Access Compliance Report

Public Rights-of-Way

(Curb Ramps)

Intersection ID: 10162	Main Street: E_SUGAR_CREEK_RD	Cross Street: THE_PLAZA	Location: NW
ADA ID: 9021665B7E3F	Ramp Type: PerpDiag	Initial Pass/Fail: Fail	Overall Compliance: No
		Severity Score: 37.5

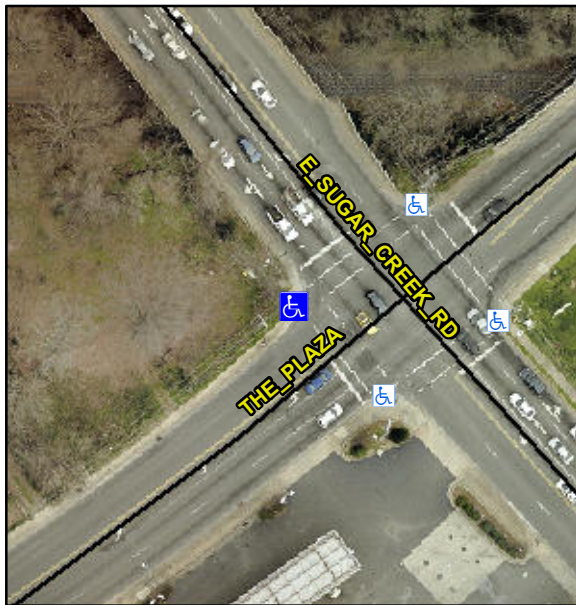
Not Found, R304.2.2, R304.5.3

Compliance	Description	Data	Compliance	Description	Data
N/A	Ramp Length (in)	59.0	No	Ramp Slope (%)	8.7
Yes	Ramp Width (in)	60.0	No	Ramp XSlope (%)	7.2
N/A	Flare Type LT	N/A	N/A	Flare Type RT	N/A
N/A	Flare Slope LT (%)	N/A	N/A	Flare Slope RT (%)	N/A
N/A	Flare Traversable LT?	N/A	N/A	Flare Traversable RT?	N/A
N/A	Landing Length (in)	N/A	N/A	DWS Provided?	N/A
N/A	Landing Width (in)	N/A	N/A	DWS Contrast?	N/A
N/A	Landing Slope (%)	N/A	N/A	DWS Length (in)	N/A
N/A	Landing X Slope (%)	N/A	N/A	DWS Full Width?	N/A
N/A	Landing Curb? (Y/N)	N/A	N/A	DWS Offset (in)	N/A
N/A	Shared Landing?	N/A			
N/A	Gutter Ponding?	N/A	N/A	Gutter Slope (%)	N/A
N/A	Gutter Lip Ht (in)	1.0	N/A	Gutter X Slope (%)	N/A
N/A	Painted X Walk1?	Yes	N/A	Painted X Walk2?	Yes
	X Walk 1 Direction	To SE		X Walk 2 Direction	To NE
N/A	X Walk 1 Width (in)	143.0	N/A	X Walk 2 Width (in)	109.0
	X Walk 1 Slope (%)	0.1		X Walk 2 Slope (%)	5.8
	X Walk 1 X Slope (%)	4.2		X Walk 2 X Slope (%)	4.8

Remove & Replace Curb Ramp With Two New Directional Ramps or Equivalent.
